Docket Number:	15-AFC-02
Project Title:	Mission Rock Energy Center
TN #:	222665
Document Title:	Nina Danza Comments What Happens When You Build in the Floodplain
Description:	Presentation
Filer:	System
Organization:	Nina Danza
Submitter Role:	Public
Submission Date:	2/21/2018 9:00:15 PM
Docketed Date:	2/21/2018

WHAT HAPPENS WHEN YOU BUILD IN THE FLOODPLAIN?

Prepared for:
California Energy
Commission

Case: Mission
Rock Energy
Center

Figure 4.1 – Typical Cross Section of Alternative 1, Soil Cement for Design Flow (Sta. 270+00)

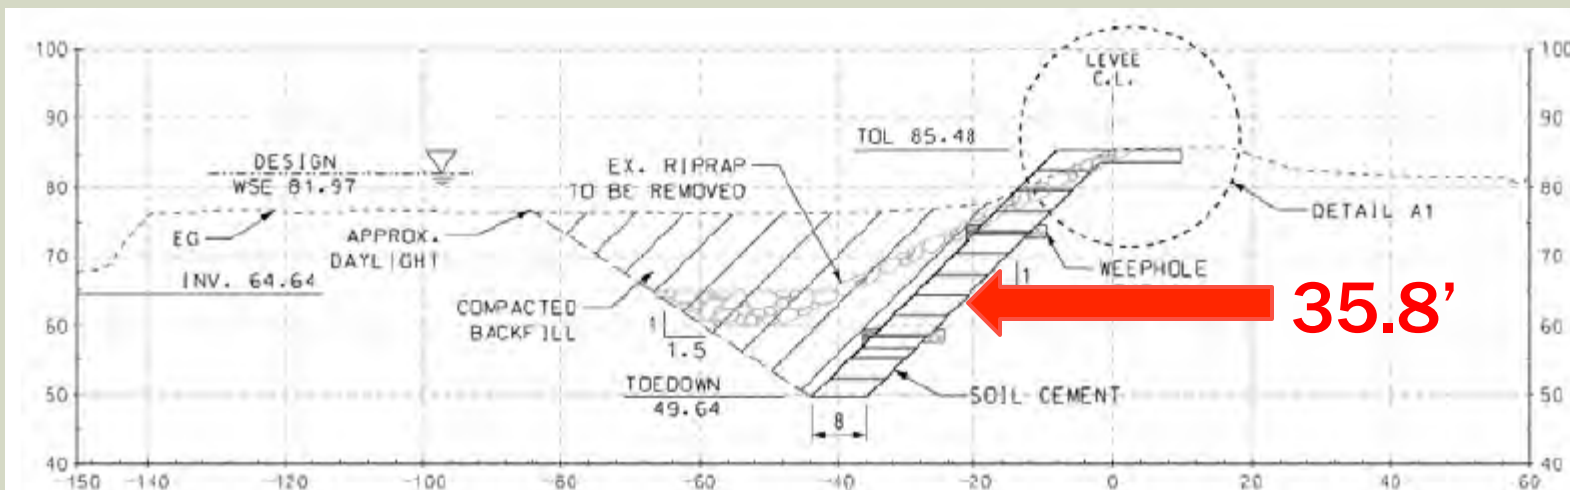
EROSION CONTROL PROPOSED DOWNSTREAM OF MREC

SANTA CLARA RIVER LEVEE REPAIR PROPOSED
8' THICK X 35.8' HIGH PAVED SIDE BANK
